## AP600 DESIGN CHANGE DESCRIPTION REPORT

June 30, 1994

Westinghouse Electric Corporation

This report covers two design changes to the AP600. The first change is a modification to the design of the reactor vessel head vent system. The second change is the elimination of the line between the Pressurizer and the Core Makeup Tanks.

Figure 2.1-1 AP600 Reactor Vessel Head Vent Subsystem

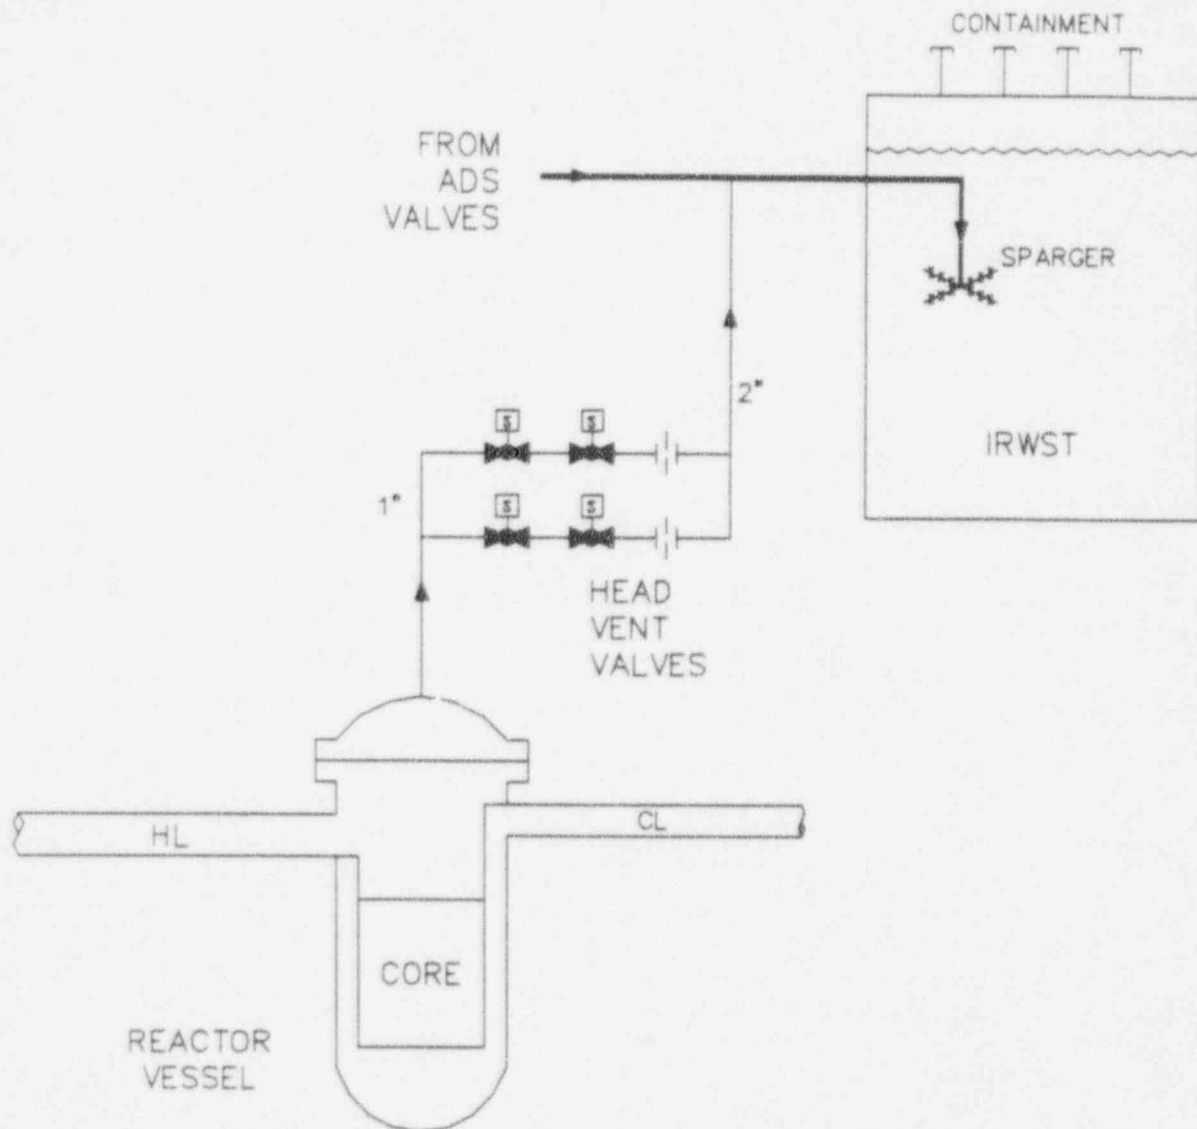
This design change modifies the reactor vessel head vent portion of the Reactor Coolant System (RCS) to provide redundant, safety-related, remotely operated head vent paths. The previous head vent consisted of one vent path with two remotely-operated isolation valves in series, and one vent path with two manual isolation valves. These vent lines are connected to the top of the reactor vessel head via a common one inch inlet header, and discharge to the IRWST via a common one inch discharge line that connects to one of the ADS discharge headers. The remotely-operated vent path was provided for venting non-condensable gases that could accumulate in the reactor vessel head as the result of a severe accident. The manual vent path was provided for RCS filling operations during startup. This design modification changes the two manual isolation valves to safety related solenoid-operated valves identical to the valves in the remotely-operated head vent path.

- removing the 3/8" flow restrictor upstream of the remotely-operated head vent valves, which changes the safety classification of the valves from safety class 2 to safety class 1,
- adding flow limiting orifices downstream of the head vent valves to limit the flow rate from the head vent path, and
- increasing the size of the head vent discharge piping connecting to the ADS discharge header from 1-inch to 2-inch pipe.

Figure 2.1-1 shows a simplified sketch of the revised design. The revised RCS P&ID and SSAR description are provided in Appendix A.

In order to provide sufficient flow capacity for accident mitigation and for manual startup venting operations, the 3/8" flow restrictor upstream of the remotely-operated head vent valves is removed. A flow limiting orifice downstream of the head vent valves has been incorporated to limit the head vent flow. The size of the discharge piping has been increased from 1" to 2" to provide sufficient vent area.

Figure 2.2-1 Passive Core Cooling System

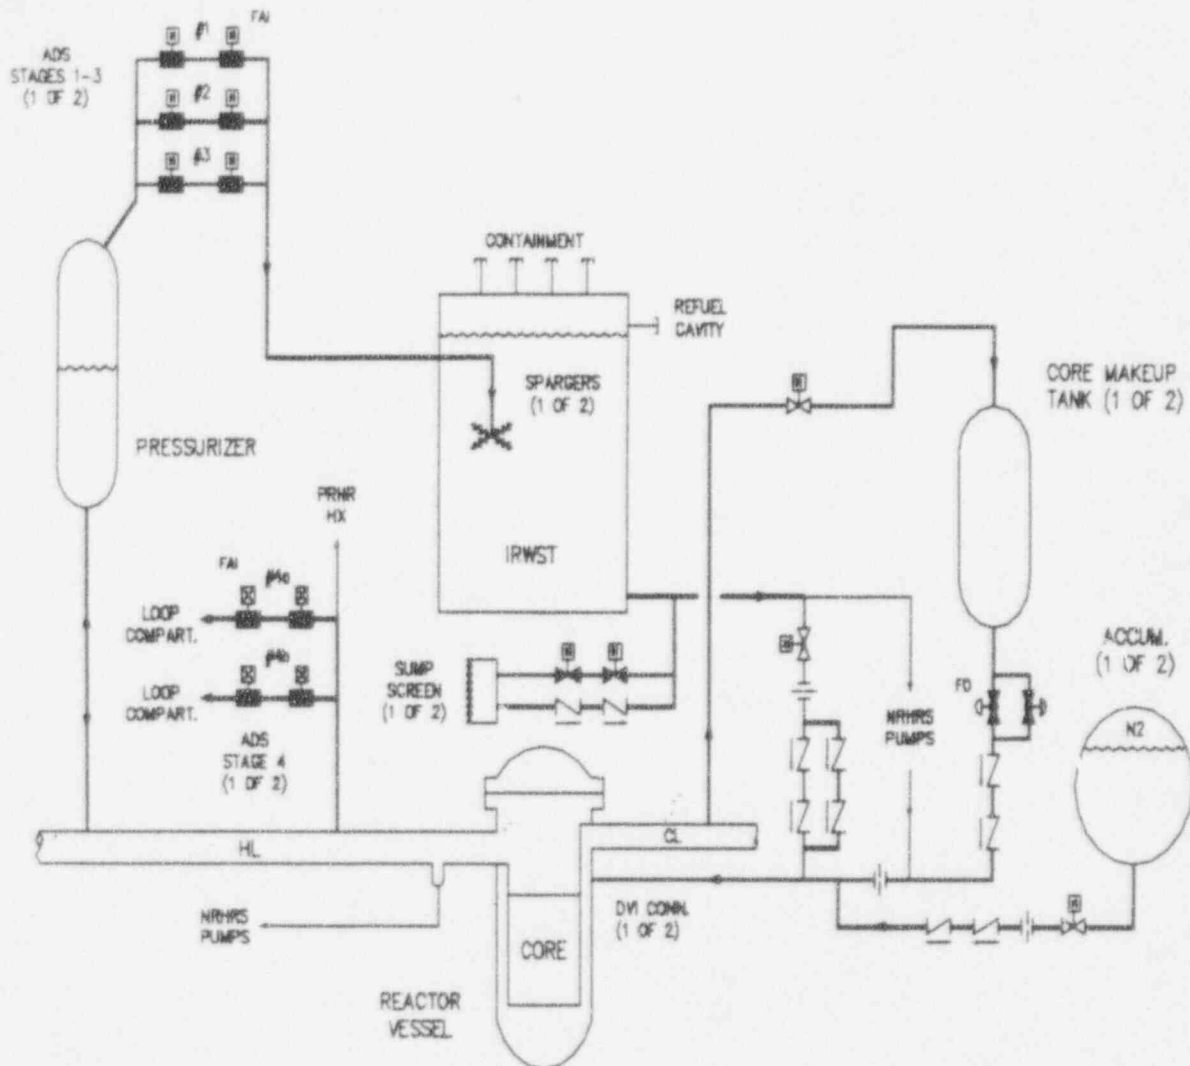
This design modification eliminates the pressure balance line connecting the pressurizer and the core makeup tank (CMT) inlet. Also eliminated is the steam trap and drain connections to the steam generator and the reactor coolant drain tank (RCDT). With the revised design, the cold leg balance line contains a single normally open motor operated valve instead of parallel normally closed air operated valves.

A high point gas trap has been added to verify that there are no non-condensables present during normal plant operation. A vent from the top of the gas trap is routed through a orifice to the RCDT. This vent is used to vent off non-condensibles in the unlikely event that they accumulate during normal operation. This line is also used in case the CMT temperature or boron concentration needs to be adjusted.

Figure 2.2-1 shows a simplified sketch of the revised design. The revised PXS P&ID and SSAR description are provided in Appendix A.

This design modification is introduced to simplify the plant design; ten remotely operated valves and four manual/check valves are eliminated. It also eliminates approximately 300 feet of pipe and two steam traps. This reduction in equipment simplifies the initial design, construction, startup / inservice testing, maintenance, inspection, and operation. It simplifies the testing and analysis associated with design certification. It also reduces the chance of unnecessary ADS actuation, as discussed below.
